UNITED STATES PATENT AND TRADEMARK OFFICE

APPLICATION NO.	FILING DATE	FIRST NAMED INVENTOR	ATTORNEY DOCKET NO.	CONFIRMATION NO.
10/792,224	03/02/2004	Sung-Pi Lu	2031002	4779

Office Action Summary	Application No. 10/792,224	Applicant(s) LU ET AL.	
	Examiner Timothy M. Ayres	Art Unit 3637

DETAILED ACTION

Hung '773 Figure 1

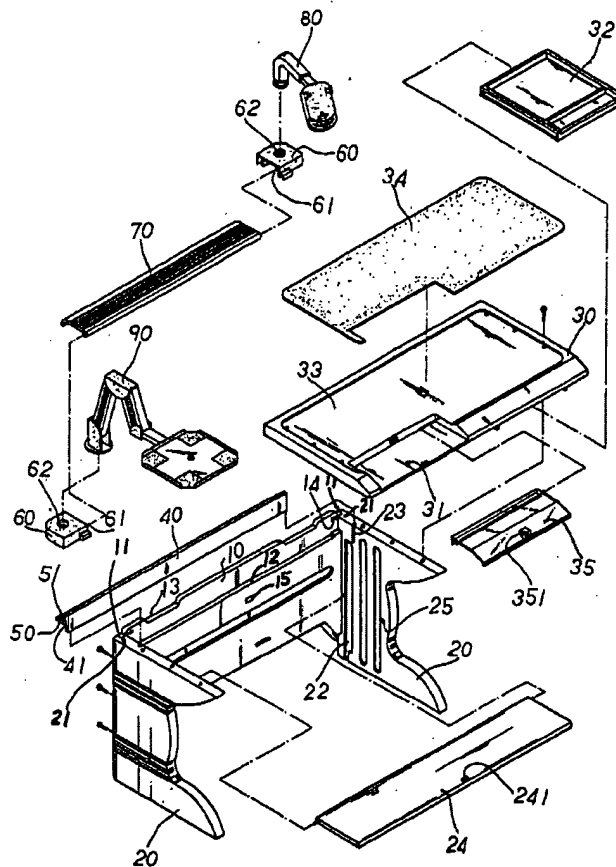
9. Claims 1 and 2 are rejected under 35 U.S.C. 103(a) as being unpatentable over US Patent 5,568,773 to Hung in view of US Patent 6,488,346 to Chen. Hung teaches a

multi-purpose table comprising two vertical support plates. Hung is silent to materials in the disclosure. A top plate (30) is connected to the vertical support plates (20) with screws and has an electronic apparatus placed on as seen in figure 4. A horizontal plate assembly (10) is connected to the vertical support plates (20) via a plurality of screws. The horizontal plate assembly (10) has a channel formed from a partitioning board (40) to allow for wires. A keyboard support (31) supports a keyboard as seen in figure 4 and is connected to the vertical support plates (20) via the top plate (30). A drawer (32) is disposed between the vertical support plates (20) and attached to the top plate (30).

Chen '346 Figure 5

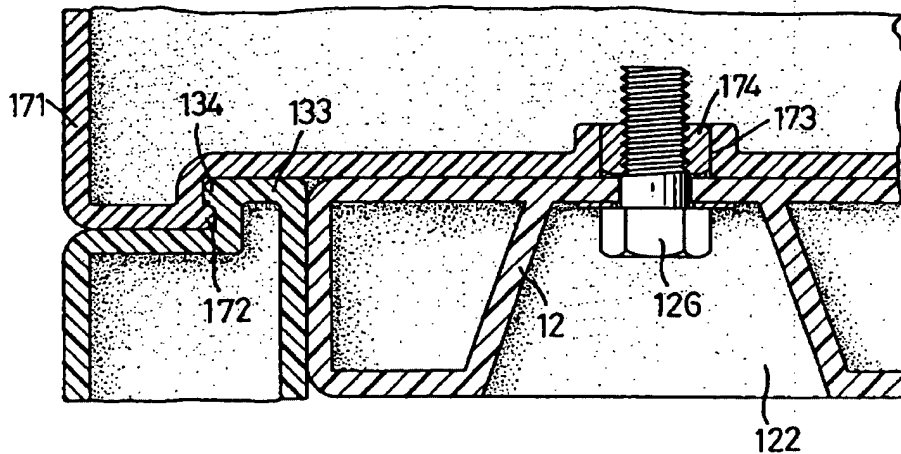
10. Hung does not disclose expressly the vertical support plates, top plate, and horizontal plate assembly made hollow and formed of blow molded plastic material and the top plate and the horizontal plate connected to the vertical support plates with screws and embedded nuts. Chen teaches a multi-purpose table (10) that has plates (17, 12, 11, 13, 14) made hollow and formed by plastics material as implied by the cavities and shapes of the details seen in figure 5 and 6. The claim is a product by process claim. The product itself does not depend on the process of making it. The product-by-process limitation "blow molding" would not be expected to impart distinctive structural characteristics to the device/apparatus. Blow molding plastic is well known and although not disclosed it is implied to be the process that made the plates (12, 17, 11) in figures 5 and 6. The plates (12, 17, 11) are attached together via a bolt (126) screwing into a nut (174). The nut is embedded in a hole (173) in the top plate (17). At the time of the invention it would have been obvious for a person of ordinary skill in the art to modify the table of Hung by making it out of plastic and having the screws attach to embedded nuts as taught by Chen so that the table is lighter and since it is common to use nuts when a material such a wood or plastic is too soft to thread a hole.

Simmons '629 Figure 1

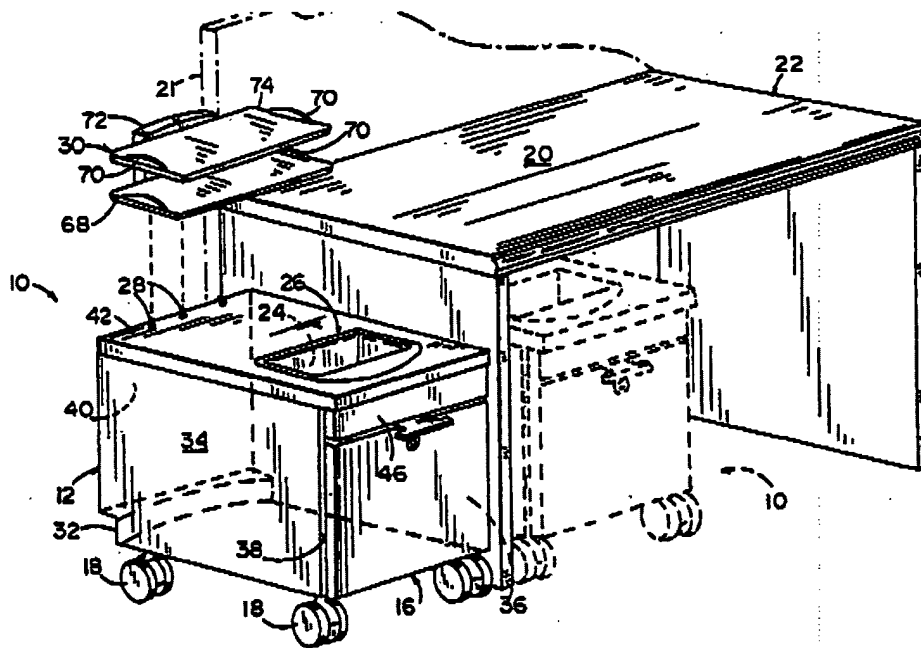
11. Claim 3 is rejected under 35 U.S.C. 103(a) as being unpatentable over US Patent 5,568,773 to Hung in view of US Patent 6,488,346 to Chen as applied to claim 1 above, and further in view of US Patent 5,205,629 to Simmons. Hung in view of Chen discloses every element as claimed and discussed above except a drawer cabinet with a drawer disposed between the vertical support plates. Simmons teaches a mobile drawer cabinet (10) with a drawer (16) used to store files. The drawer cabinet (10) is disposed between the vertical support plates of the workstation (22) and comprises a tray (26) to store other smaller objects as seen in figure 1. At the time of the invention it would have been obvious for a person of ordinary skill in the art to modify the table of Hung in view of Chen by adding the drawer cabinet as taught by Simmons so that files or other objects can be stored near the table.

Pierce '562 Figure 3

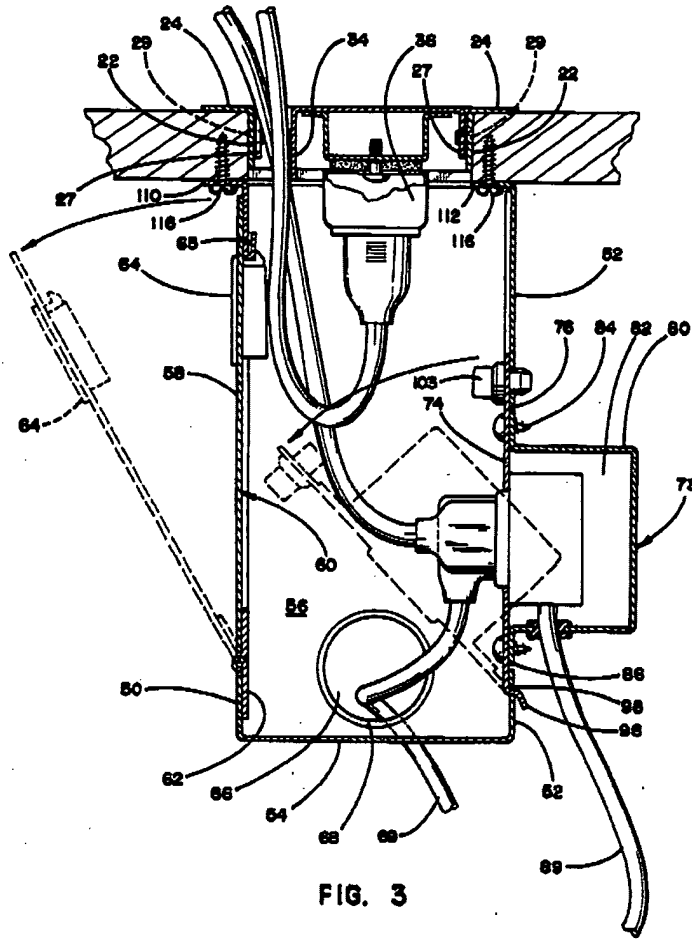
12. Claims 4-14 are rejected under 35 U.S.C. 103(a) as being unpatentable over US Patent 5,568,773 to Hung in view of US Patent 6,488,346 to Chen as applied to claims 1-3 above, and further in view of US Patent 5,231,562 to Pierce. Hung in view of Chen discloses every element as claimed and discussed above except a hub box for electrically connecting the electronic apparatus, the hub box mounted to and in a cavity on the horizontal plate assembly, the hub box comprising a power line port, a signal line port, and a power switch, and the table comprising an adapter electrically connected to the hub box. Pierce teaches a table with a hub box mounted to and in a cavity on the horizontal plate assembly. The hub box (73, 90) has a power line port (91) and a signal line port (99) that is used for telephones. The hub box (73, 90) has a power switch (91) to selectively connect the alternate current power source (89). The horizontal plate

assembly (52) has a channel (56) formed by a partition (58) to allow for wires. At the time of the invention it would have been obvious for a person of ordinary skill in the art to modify the table of Hung in view of Chen by adding a hub box to the horizontal plate assembly as taught by Pierce so that the wire management system (hub box) is adaptable to a wide range of desktop electronic apparatuses (Pierce '562, Col 1, lines 21-35).

13. Regarding claims 8 and 12, the office takes official notice that adapters to convert alternate current into direct current are well known and very common with computer accessories such as printers, scanner, speakers, etc. Therefore it would have been obvious for a person of ordinary skill in the art to connect an adapter to the hub box of Hung in view of Chen and Pierce to power a computer accessory.
